H. B. ROBINSON STEAM ELECTRIC PLANT

UNIT 2

INSERVICE INSPECTION PROGRAM

TECHNICAL EVALUATION REPORT

2. Page 5

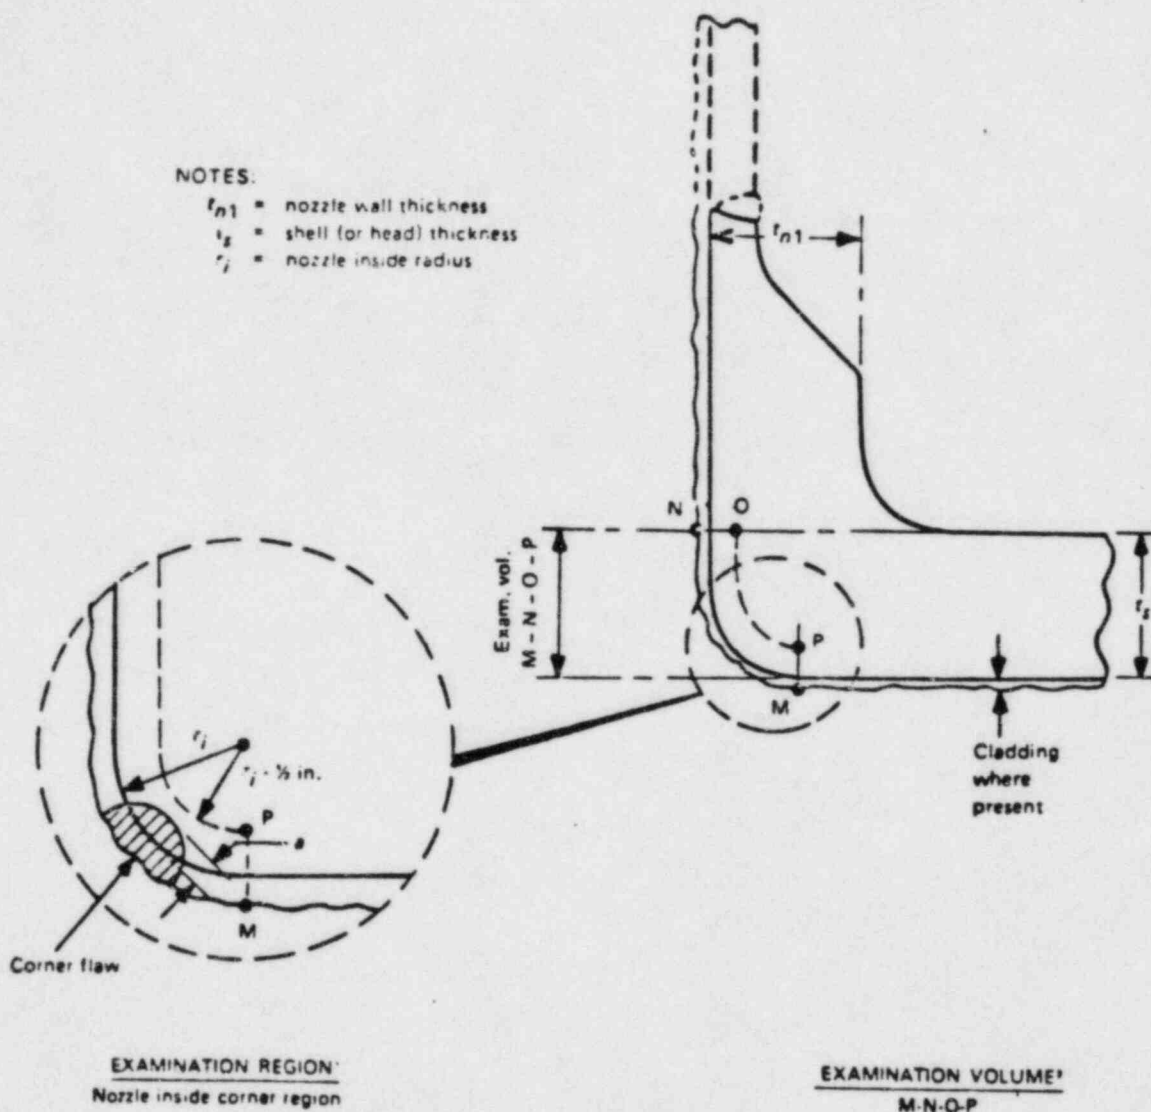
The only additional information supplied by the licensee was a simplified drawing of the Pressurizer. This drawing provided little clarification beyond the drawing originally supplied in the plan. The evaluation included in the TER is valid based on the information available to the reviewer. Additional explanation by the licensee would be required before the TER could be revised.
